**AGENDA**  
**Historic Yorktown Design Committee**

## MEMORANDUM

**SUBJECT:** Application No. HYDC-263-24, Jeffrey Vance, 114 Ballard Street: New 6 ft. wooden picket backyard fence

- The fence will be designed as a tall picket fence with a scalloped top (see pic)

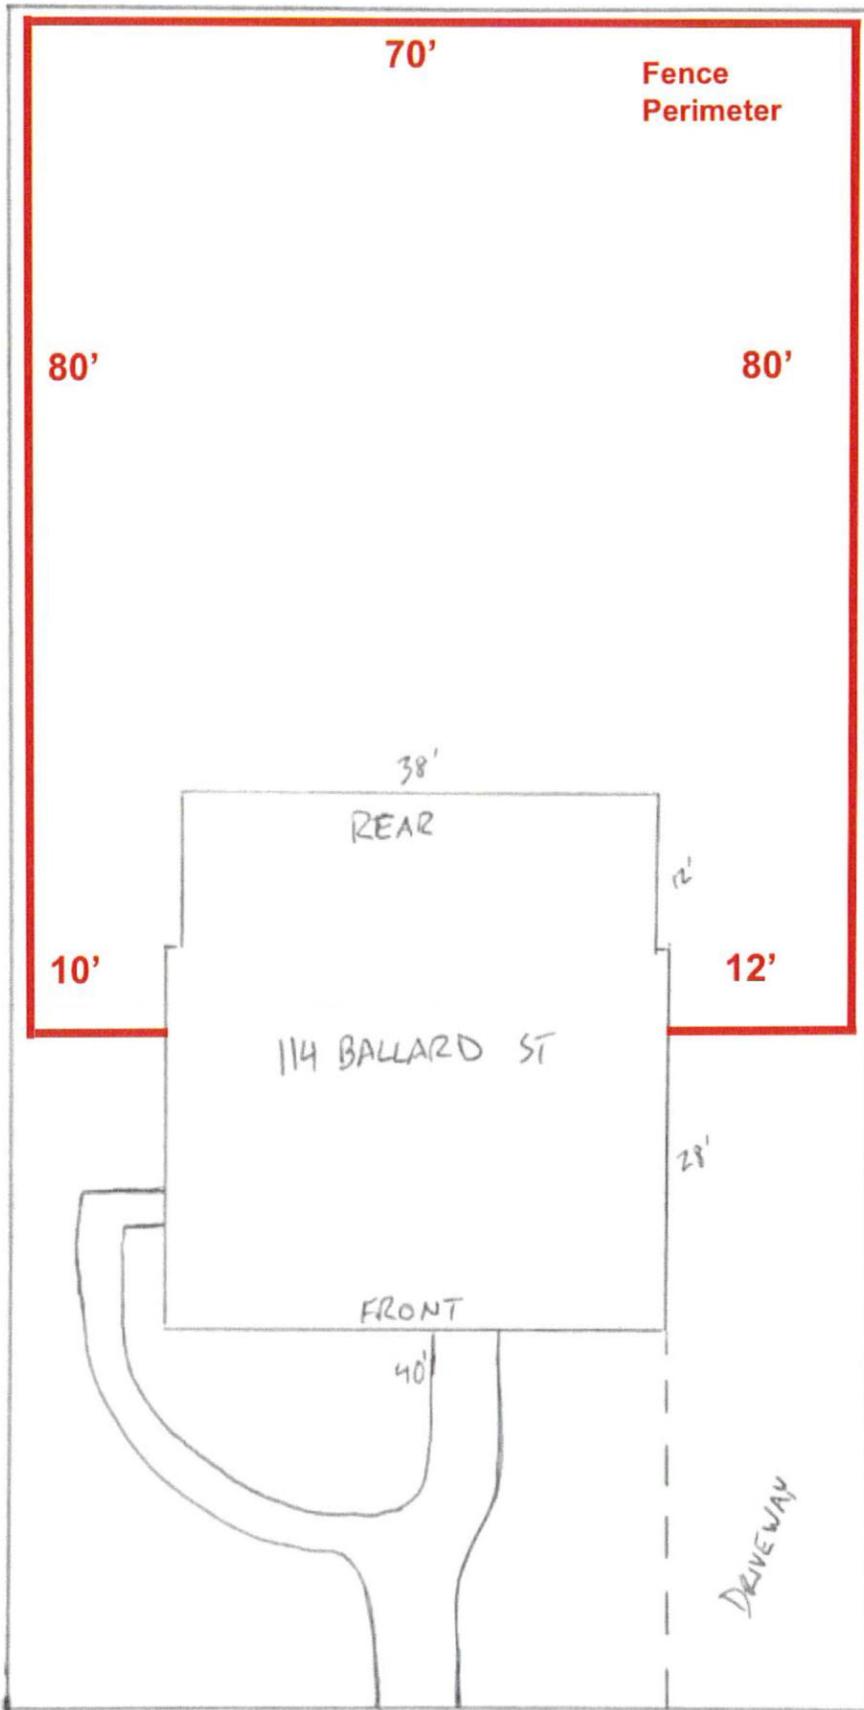
| <p>Fences should be simple in overall design, painted white, between 36"- 48" in height, and have appropriately sized and spaced pickets with a simple, geometric profile. Pedestrian entry gates should be of the same material, color, and general design as the fence.</p>  | <p>The proposed fence would have a scalloped top design and would be finished with a clear stain, rather than painted white. The height would be 72" or six feet (6') in height. The size and spacing of the pickets is unknown. The pickets of the proposed scalloped style fence would not be geometric in profile. The pedestrian entry gate is proposed to be of the same material, color, and general design as the fence. The proposal is not consistent with this guideline.</p> |

environment for his children and dog. The proposal meets the criteria of the County Code, but in staff's opinion, the fence should be a traditional picket fence, rather than a double-sided offset picket fence. It should be painted white, and designed with a straight top, rather than the proposed scalloped top design, to meet the guideline recommendation that the picket fences have a simple, geometric profile. Because the fence would be located in the side and rear yards, staff believe the fence could be constructed at the proposed six-foot (6') height and be substantially consistent with the Design Guidelines. Accordingly, it is recommended that the Committee approve the proposal with the following conditions:

1. Except as set forth herein, the fence shall be constructed in accordance with the sketch plan and narrative description provided by the applicant and received by the York County Planning Division on September 27, 2024, copies of which shall remain on file in the office of the Planning Division.
2. The fence shall be painted white on or before November 20, 2025.
3. The fence shall not have a scalloped top design and shall feature a flat or straight top ridge.
4. The fence shall not be double-sided or feature offset pickets. The fence shall be constructed with a traditional picket fence design.
